No. 277
Date: 18.06.2019

Single Modular System Design - UPDATE

PRODUCT UPDATE

Old (PN 51207080)

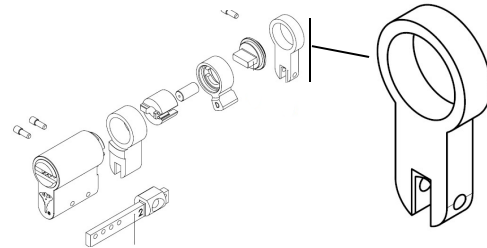
The new bar (connector) for single modular, result a change also of the adaptor for single modular cylinder.

The M5 thread is part of the new bar (connector).

The new Adaptor is compatible **only** with the new single modular bar (connector).
Old Adaptor will be available until you will finish your old bars (connector) stock.
Please verify handling this transition effectively.

New (PN 84400071)
